**BPC WEST SEWERSHED PACKAGE 5C  
SAWS Solicitation No. CO-00458  
SAWS Job No. 21-4516**

**ADDENDUM NO. 1  
September 28, 2021**

SHEET NO. K-05  
57 OF 98

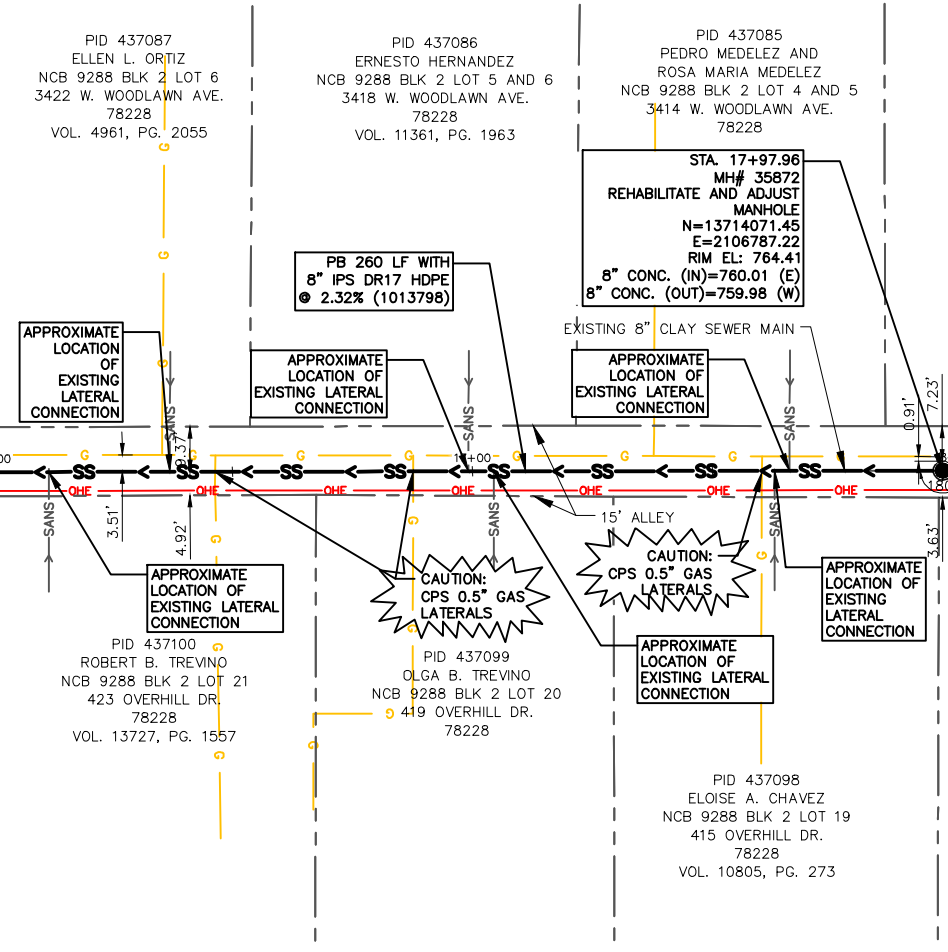
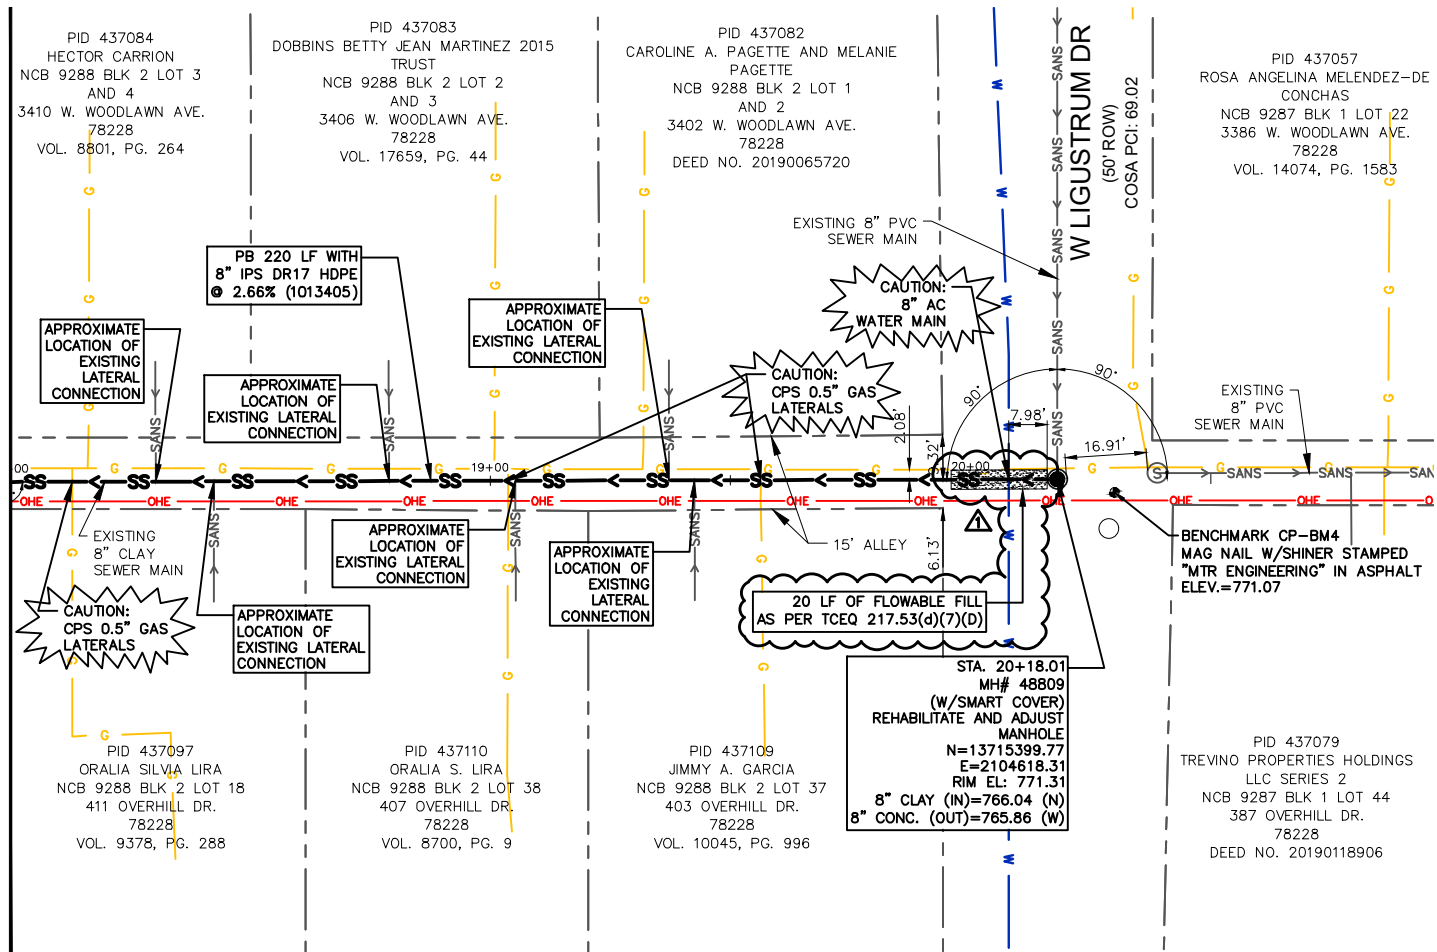
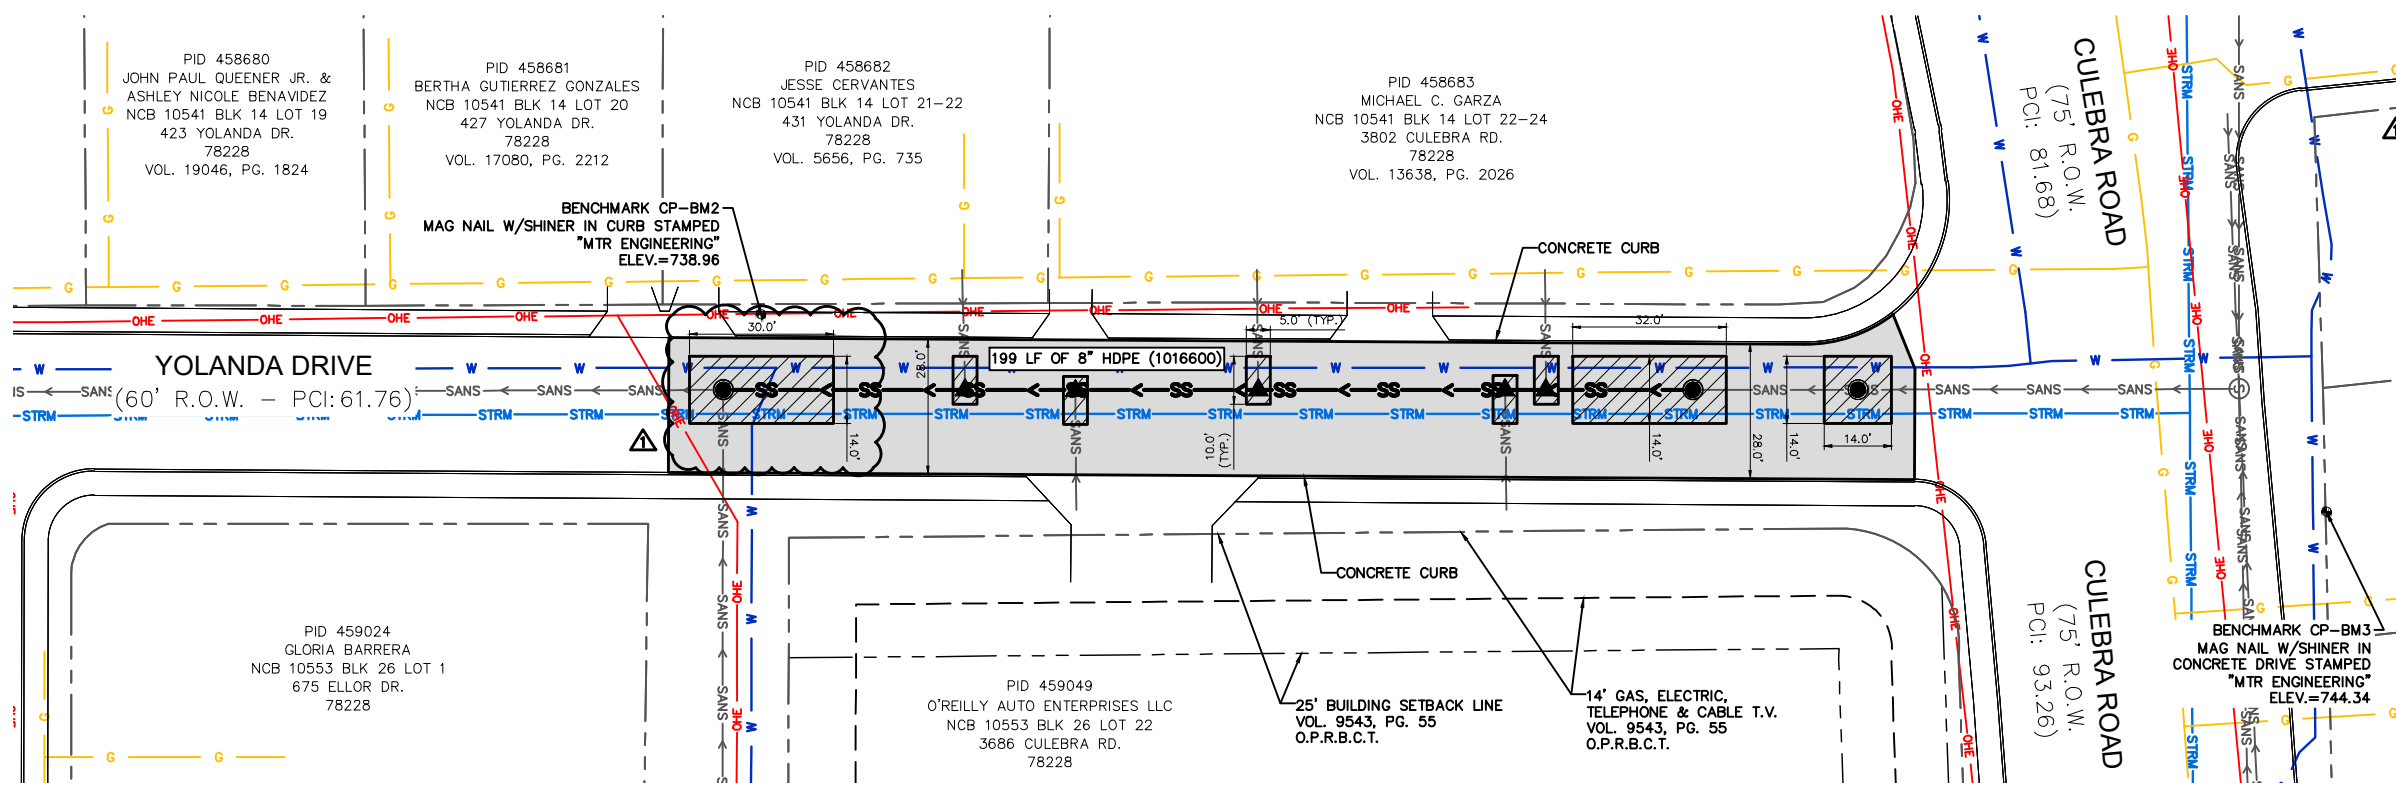
3. Sewer Rehabilitation Plan Sheets A-04, J-04, K-05, and M-04 – Revised plan sheets specify Flowable Fill at water crossings per TCEQ 217.53(d)(7)(D) and include an additional note regarding the flowable fill pour. Line Item Spec No. 413.1 Flowable Fill has been added to the Estimated Quantities.

- EXCAVATION, BACKFILL, HAULING EXCAVATED MATERIAL AND ALL OTHER NECESSARY WORK TO COMPLETE FLOWABLE FILL POUR IS CONSIDERED SUBSIDIARY TO THE FLOWABLE FILL LINE ITEM.

NOTES	INITIALS	DATE
DESIGNED BY		
REVIEWED BY		
SCALE:		
SHEET NO.	M-03	
	64 OF 98

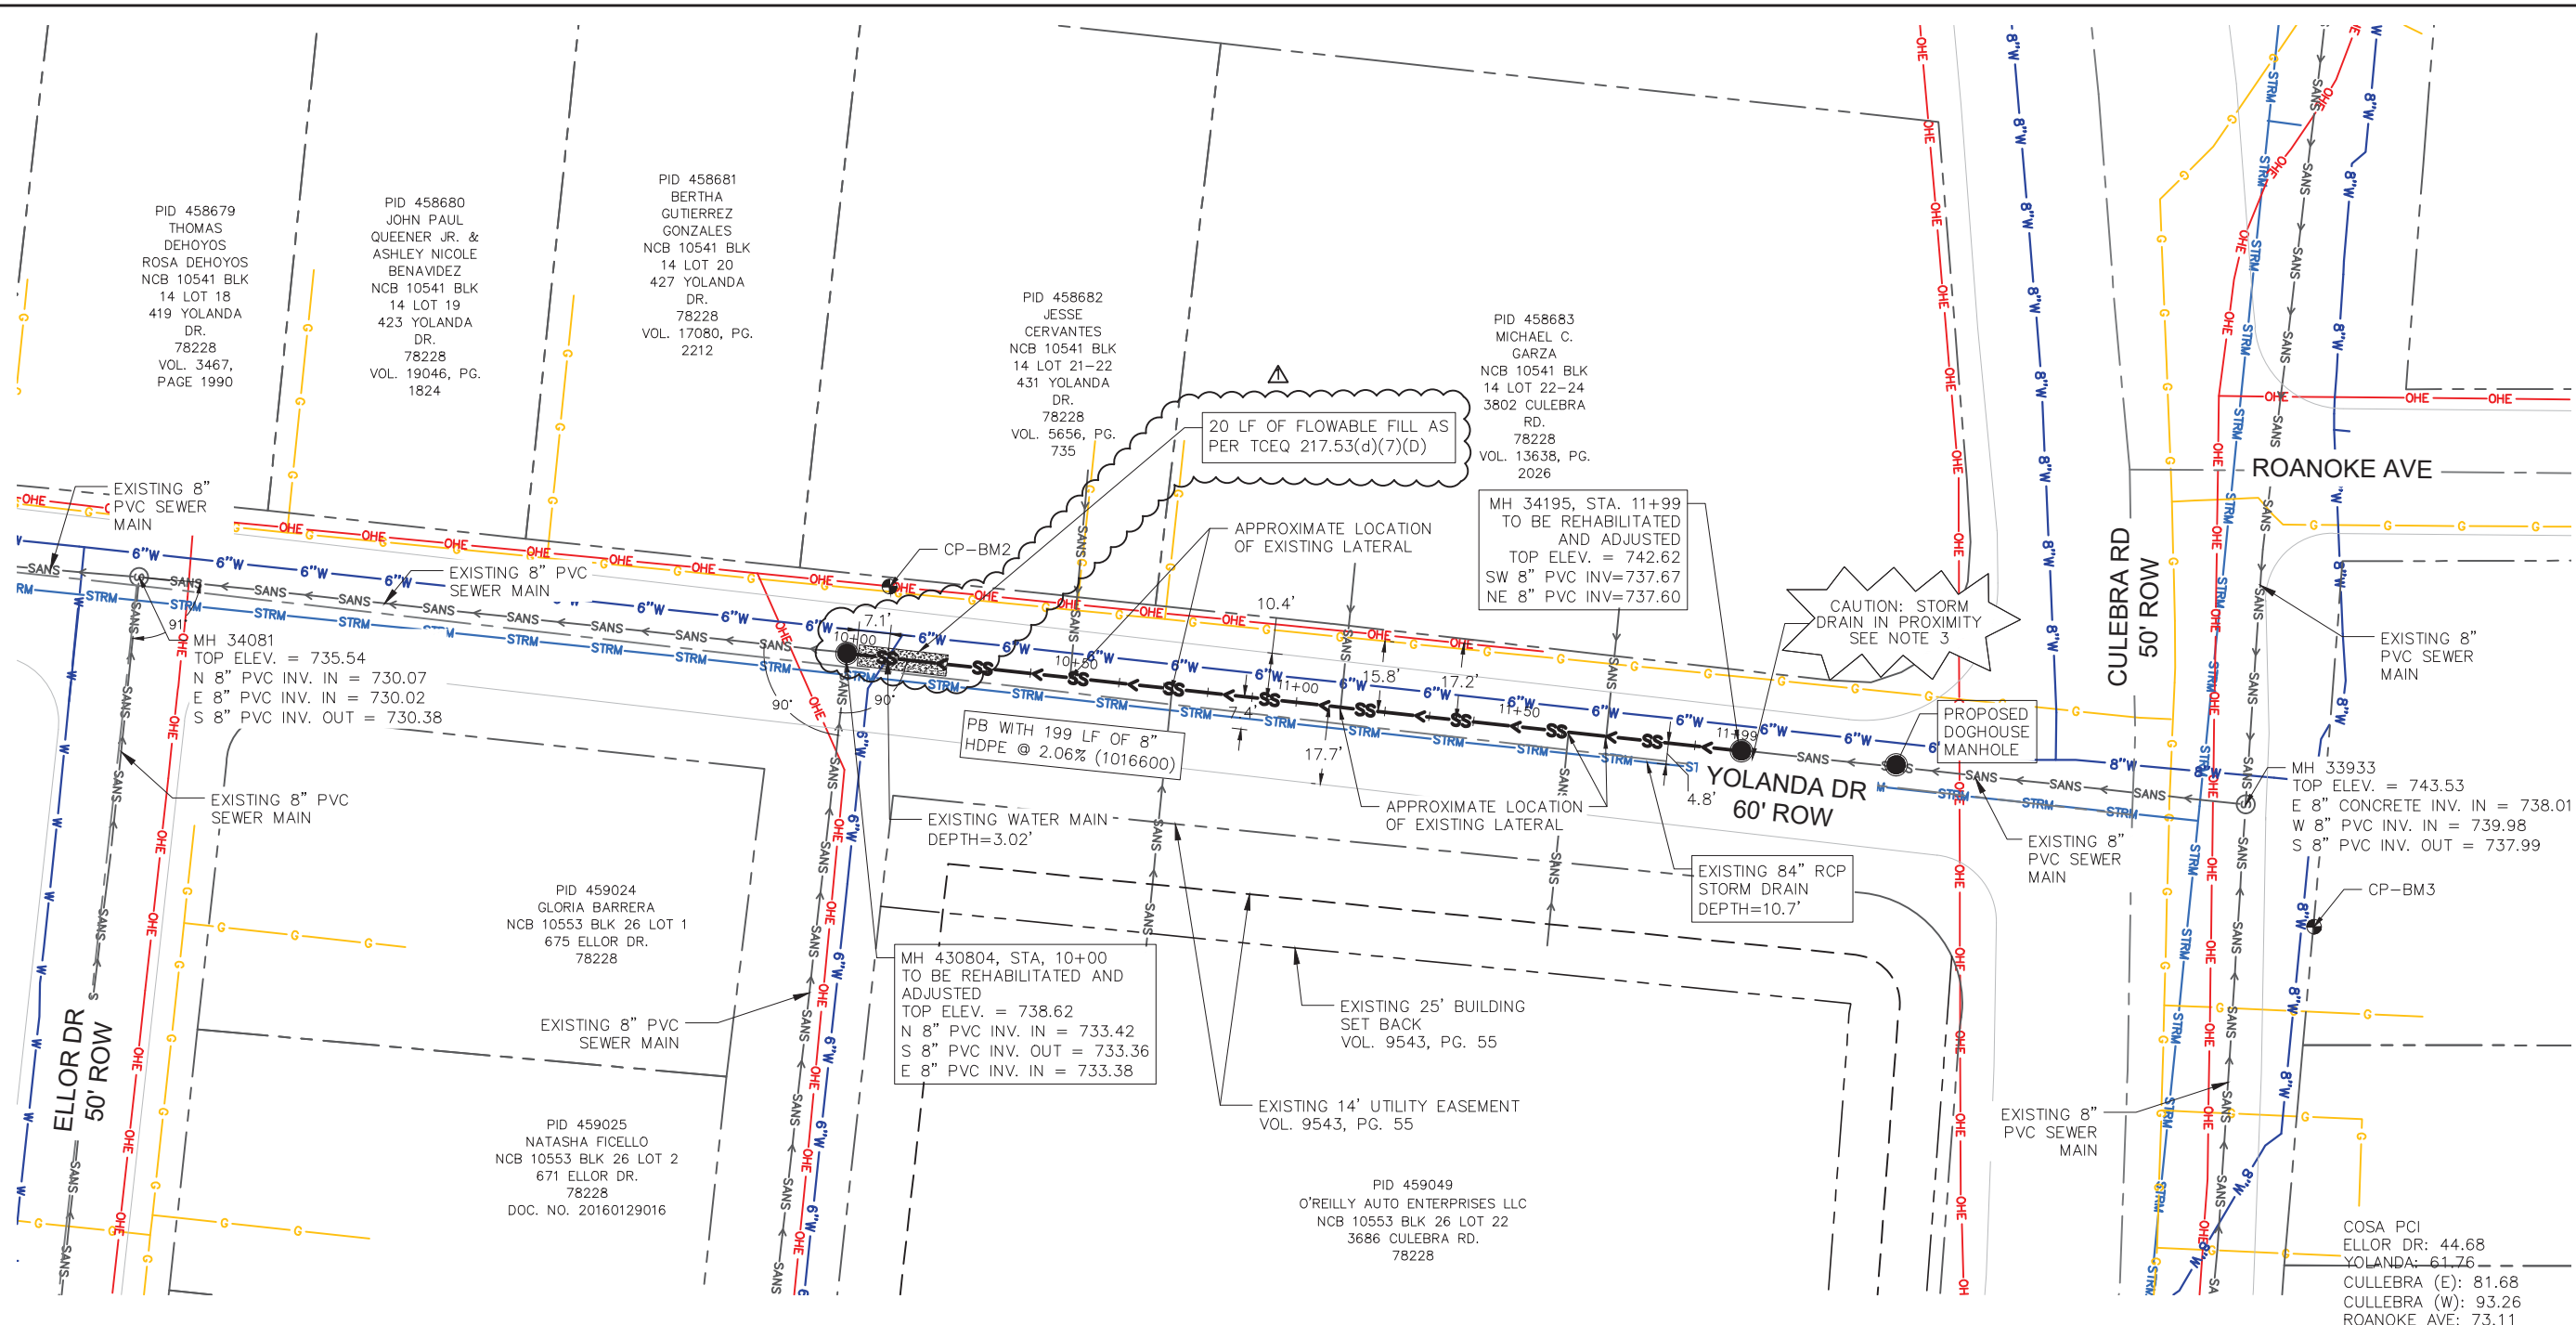
4. Pavement Repair Plan Sheet M-03 – Revised plan sheet includes updated Quantities Table. The quantities for Line Item Spec No. 205.4 Hot Mix Asphalt Concrete Pavement Type D (2” Compacted) and Line Item Spec No. 206.1 Asphalt Treated Base (ATB) (10” Compacted Depth) have been increased.
